GM Splash Shield Template and Tech Sheet

P-Series Splash Shield RH 15983041

EXHAUST MANIFOLD AND PLUG WIRE FAILURE

Inadequate Engine Compartment Air Flow

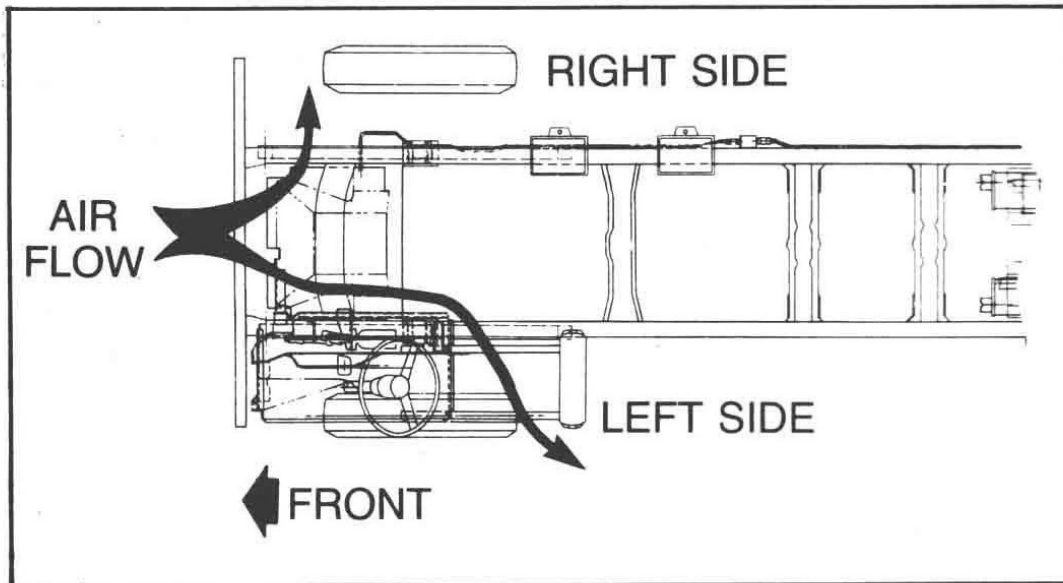
Chevrolet has determined that right side exhaust manifold and right side spark plug wire failure may be the result of inadequate air flow. This is due to the absence of a wheel-well panel on the right front wheel opening. This situation allows necessary engine cooling air flow to exit the engine compartment prior to passing the exhaust manifold and spark plug wires and thereby cooling the manifold and spark plug wires as occurs on the left side of the engine compartment.

Corrected Engine Compartment Air Flow

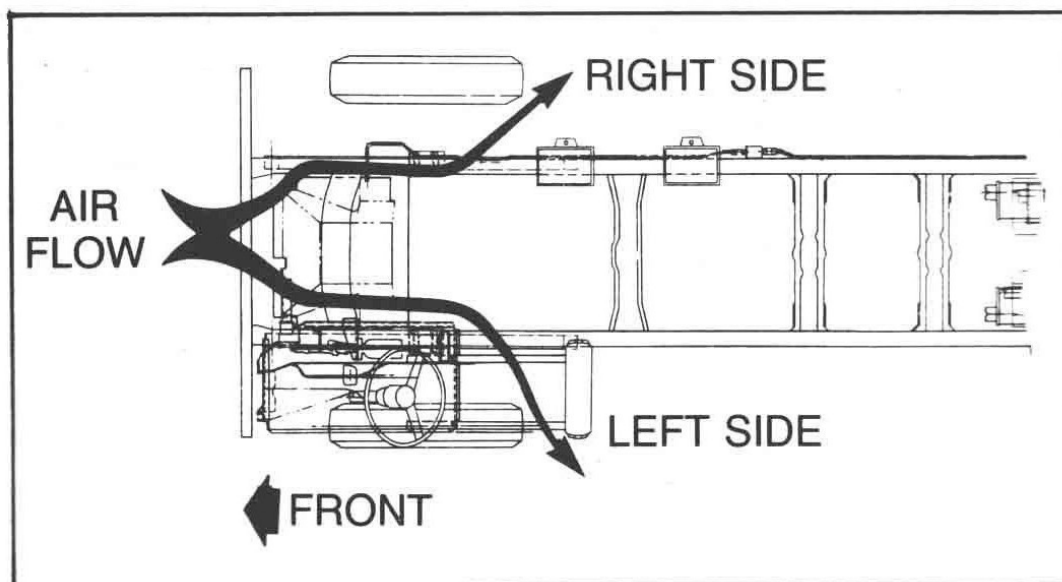
This condition can be corrected by fabricating a metal panel similar to the one used on the left side of the vehicle. Adding the panel forces the air flow to pass along the right side of the engine compartment thereby providing a cooling effect and greatly extends the manifold and spark plug wire life.

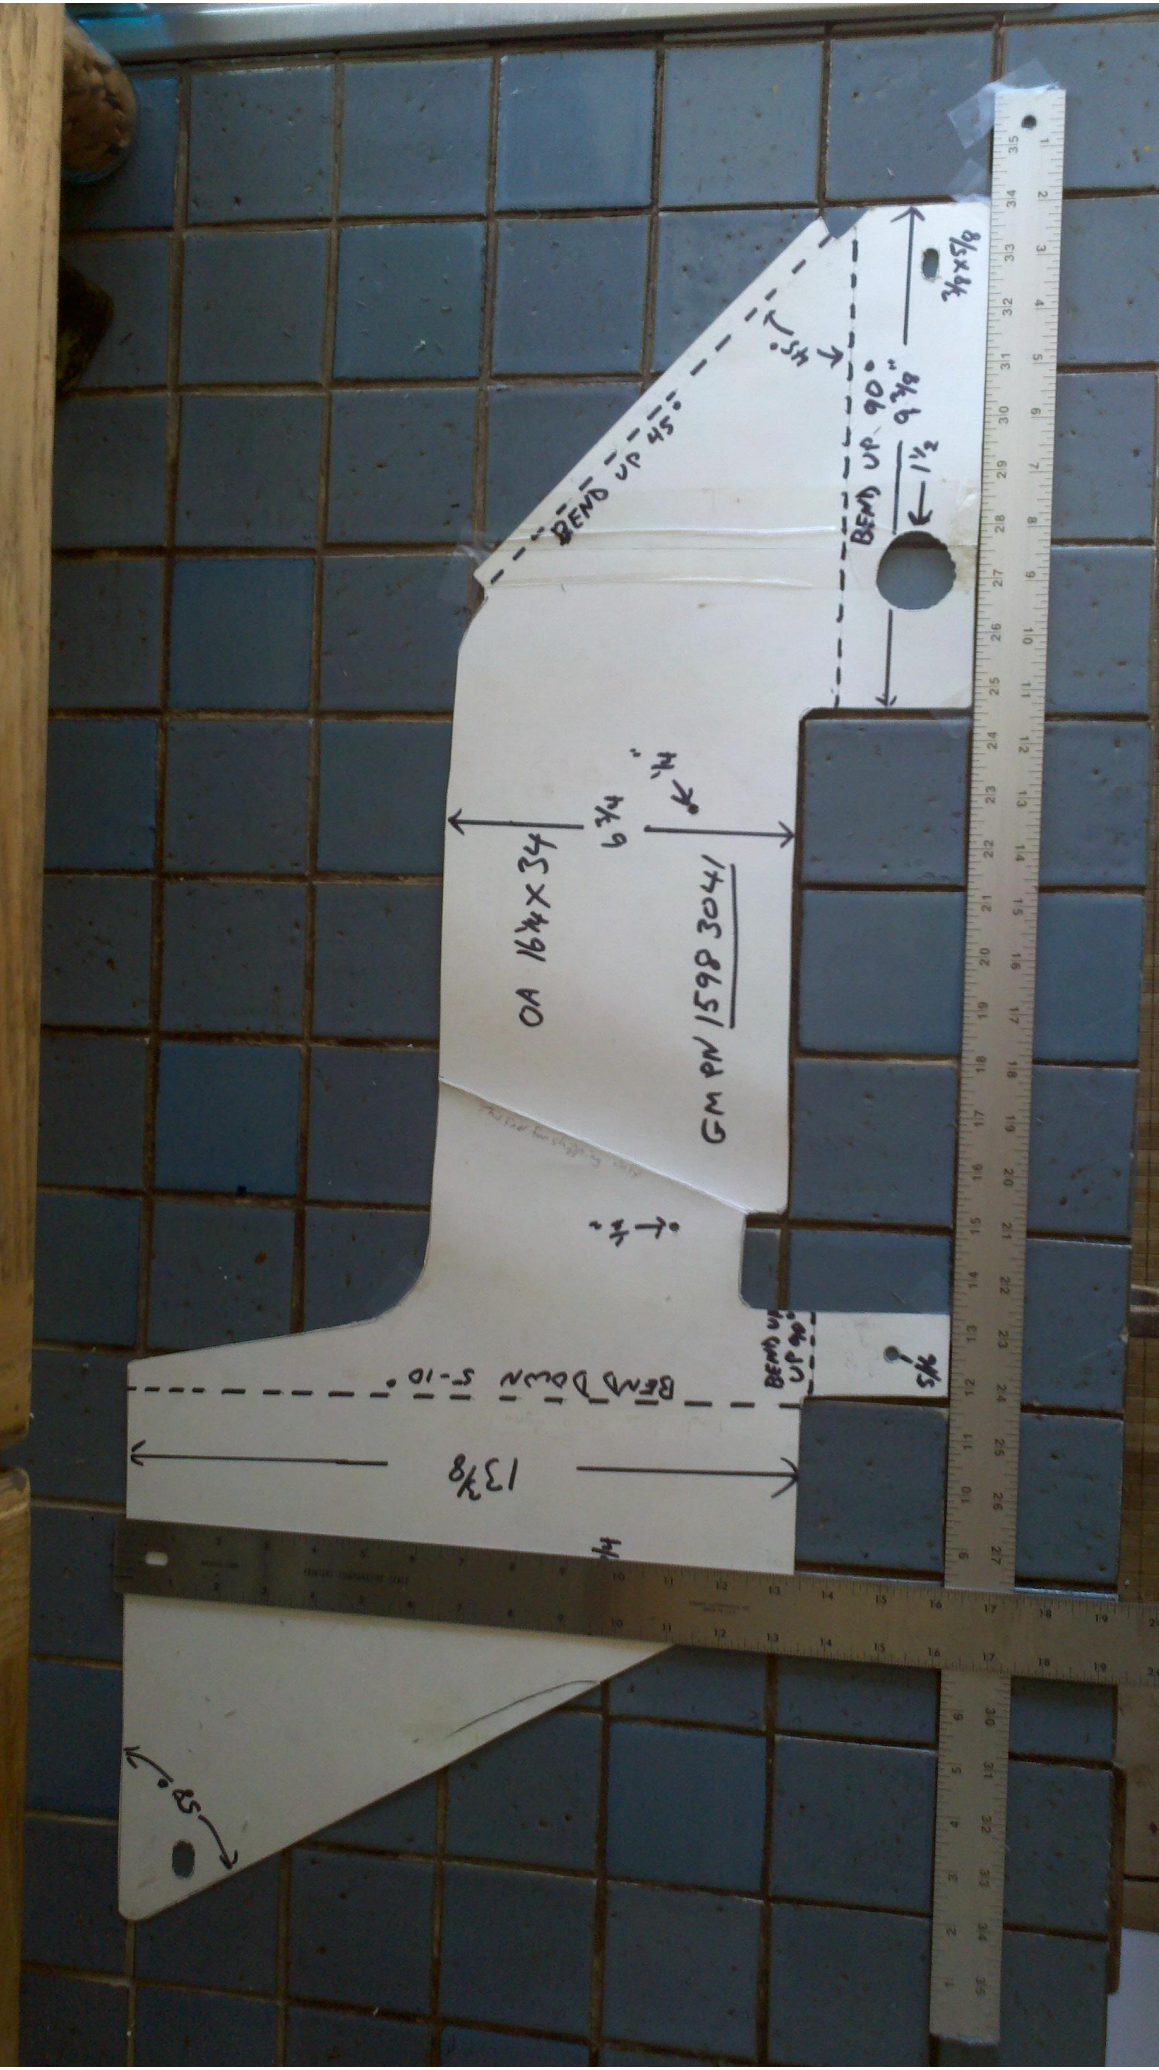
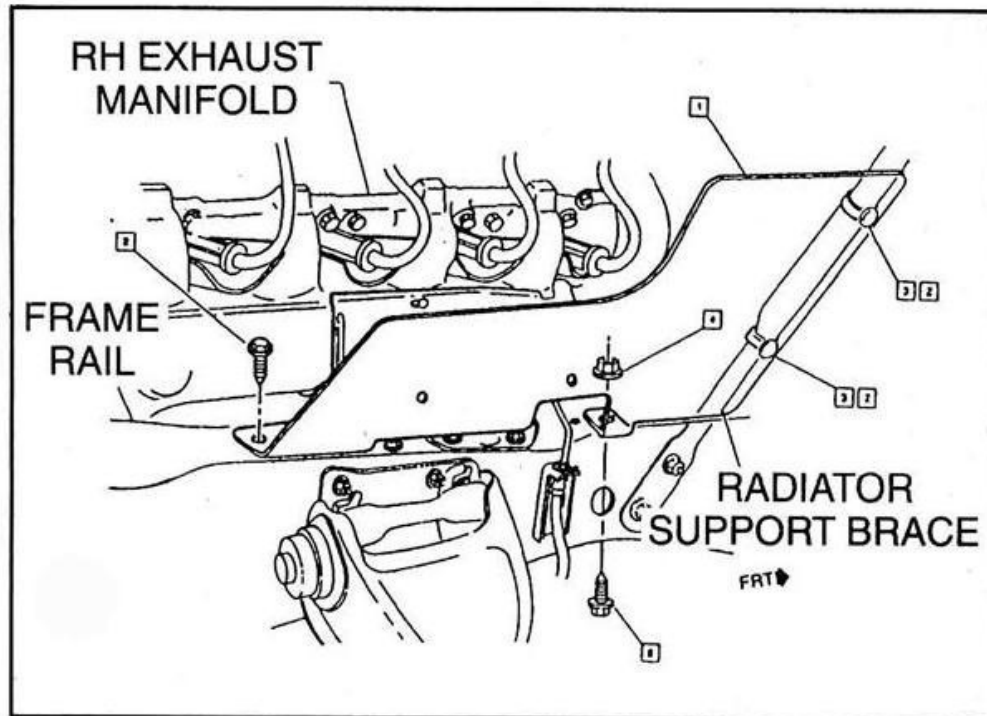
Care must be taken in the design of the right side panel as to provide proper clearances around any hoses, wires and engine dress items and also to provide clearance for the tire throughout its movements. The panel should extend rearward to a point parallel to the number seven spark plug wire. The panel should be shaped and positioned similarly to the left side panel currently installed on the vehicle. Care must be taken to leave an opening at the rear of the engine compartment to allow cooling air to exit the engine compartment as on the left side panel.
